Environment Agency response to BEEMS Scientific Position Paper SPP107 Worst case glass eel entrainment assessment. (HPC-DEV024-XX-000-RET-100xxx Revision 02)

NNB GenCo (HPC) provided Cefas's BEEMS Scientific Position Paper SPP107 Worst case glass eel entrainment assessment (HPC-DEV024-XX-000-RET-100xxx Revision 02) for HPC in July 2020.

The EA has reviewed SPP107. A summary of the main points follows:

Figure 2 - Plots of the HPC-specific net shoot and haul points, relative to the proposed HPC intake locations (Source: TR247).

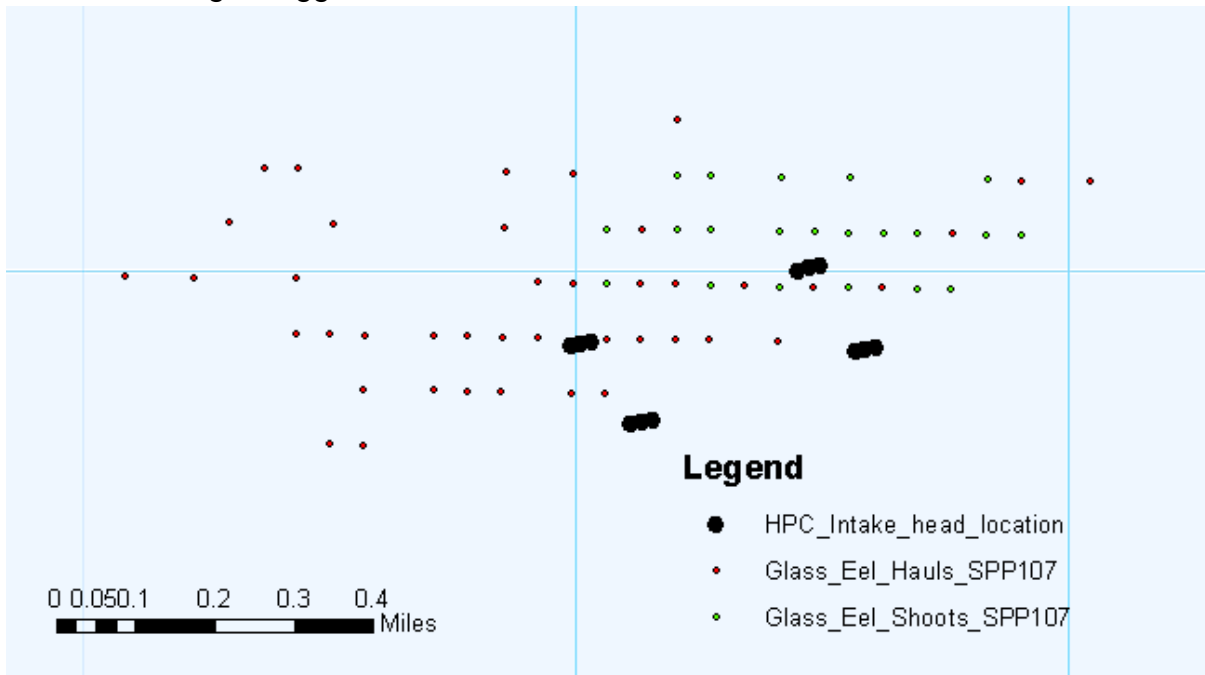
The EA also recognise that the glass eel trawl surveys were novel, the first to be conducted in an estuary of this size and contain inherent imprecision, as detailed in Walmsley *et al.* (2018). However, they do offer excellent coverage of the specific area of the proposed intakes (Fig.2).

Each of the four intake heads will be 35.4m long and approximately 10m wide, along the direction of the cross-estuary transect proposed in SPP107 – collectively 40m of transect length. 51 trawls were carried out in the immediate vicinity of the proposed HPC intake heads using a 1.18m-wide sampling net. Assuming that at each trawl, a previously-unsampled part of the transect was surveyed, then a transect width of approximately

60m would have been surveyed, giving high resolution data with good coverage of the intake head locations. Plots of the shoot and haul positions of these 51 pooled trawls in Fig 1 suggest this is a reasonable assessment.
